**Preliminary Notification: Draft Planning Proposal – Appin (Part) Precinct No 2.**

I refer to Council's letter of 12 January 2024 regarding *preliminary notification* of a draft Planning Proposal ('The Appin (Part 2) Precinct for Urban Development' dated 23 November 2023) for land within the Greater Macarthur Growth Area (GMGA).

## **ATTACHMENT 1 - DETAIL**

**Map 1.** Location of Sydney Drinking Water Catchment and Special Areas with respect to the South Site

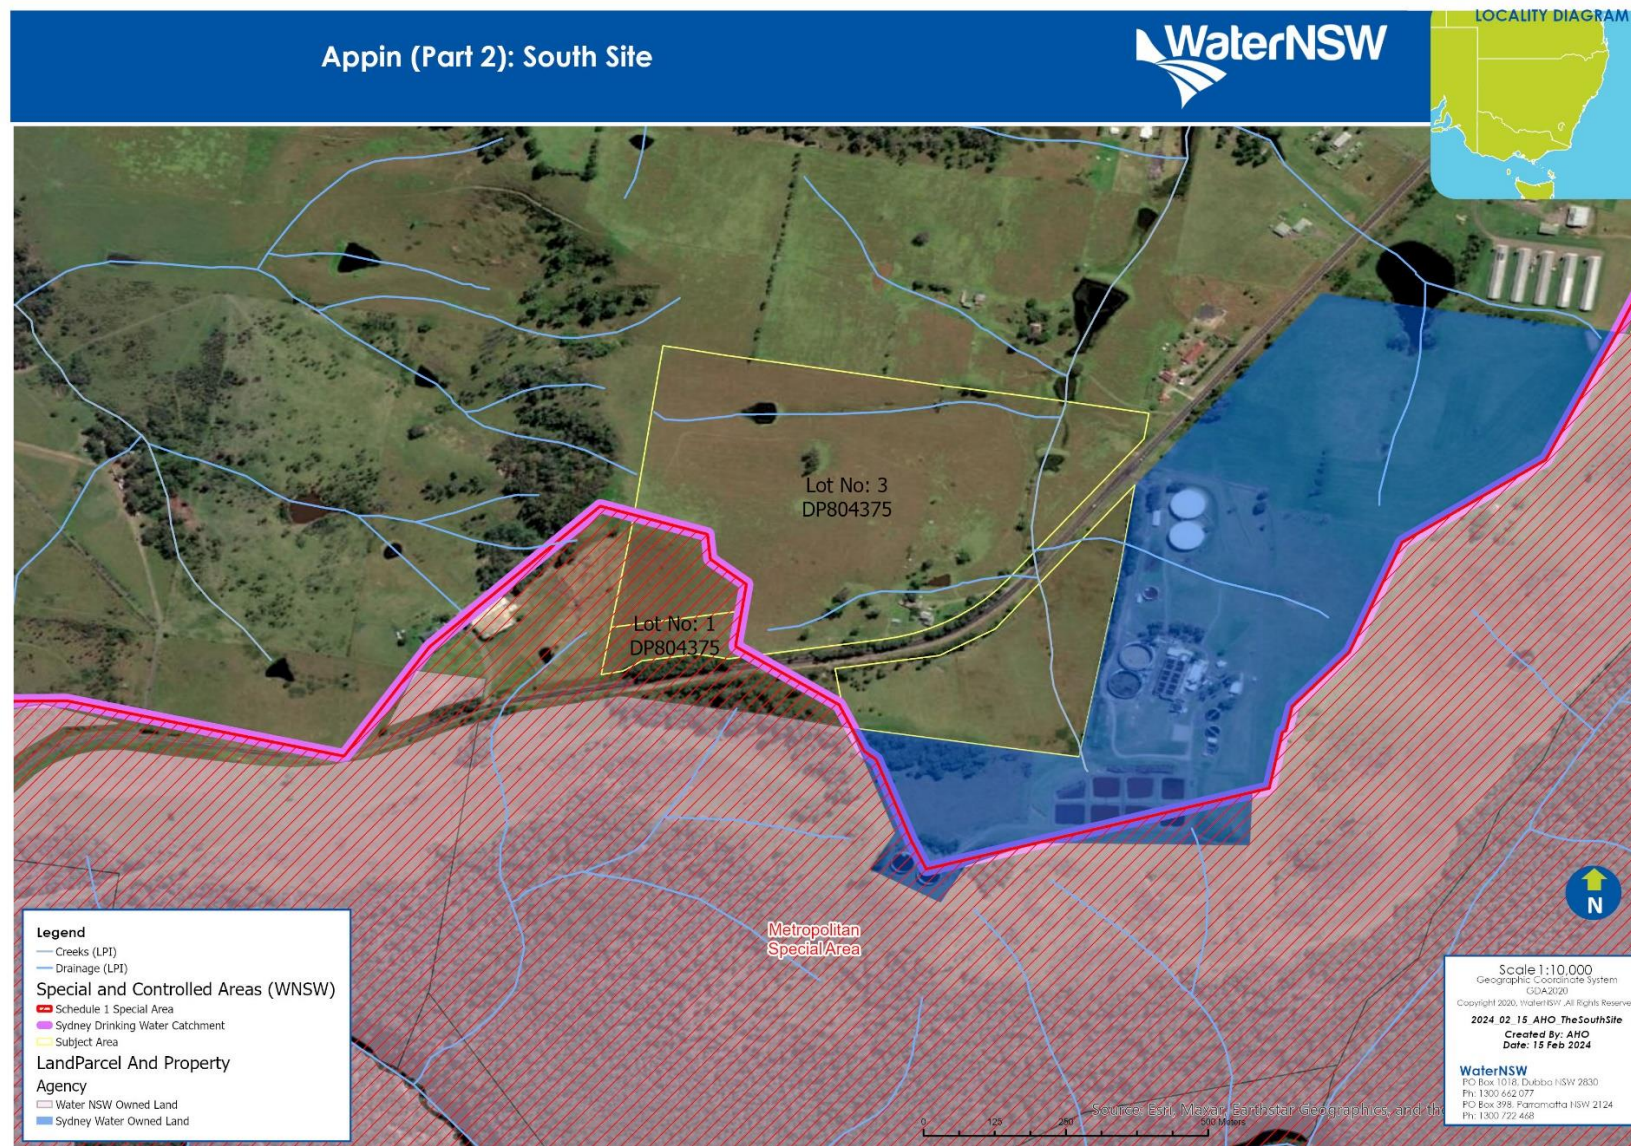
We include a map of the South Site and its relationship to the SDWC and Special Area designation (see Map 1 at the end of this submission). Land within the SDWC attracts the planning controls such as the provisions of Parts 6.2 and 6.5 of the B&C SEPP, which includes the requirement for new development to have a neutral or beneficial effect (NorBE) on water quality. Special Areas are so declared to protect water quality and maintain ecological integrity. Public access to Schedule 1 Special Areas is prohibited when these areas are on land owned or managed by WaterNSW, or falling under National Park Estate. However, Special Area controls on private land (such as occurs in the Appin (Part 2) South Site area) are limited and mainly relate to animal management (see Water NSW Regulation 2020).

The land *north* of Wilton Road includes land that is declared Schedule 1 Special Area. This land also lies within the declared SDWC. The Special Area land in Lots 1 and 3 north of Wilton Road will be classified as 'district open space' under the Structure Plan. The Planning Proposal further identifies that the open space land will be used as a district park for active recreation such as sporting fields (pages 134 and 136). We support the classification of open space over this area of land as proposed in the Structure Plan. The type of open space use may need to consider other values such as ecology and cultural heritage given the site's proximity to the Appin Massacre Cultural Landscape. The open space area may also need to be managed as an Asset Protection Zone (APZ). To minimise water quality risks to the SDWC, we need to confirm that the boundary aligns fully with the Special Area and SDWC boundary.

The land *south* of Wilton Road borders the SDWC and Special Area land, with a very small portion of these lands overlapping with the Planning Proposal site in the south-west. The

south-west corner borders the WaterNSW Special Area land where public access is prohibited.

- All Asset Protection Zone areas will need to be kept on the site of the development.
- If urban development is proposed on the land south of Wilton Road:
  - the adjoining Water-NSW owned-land will need to be separated by an APZ incorporating a perimeter road and located on the site of the development.
  - Suitable security fencing will need to be emplaced by the developer to maintain the security of the WaterNSW -owned Special Area land.
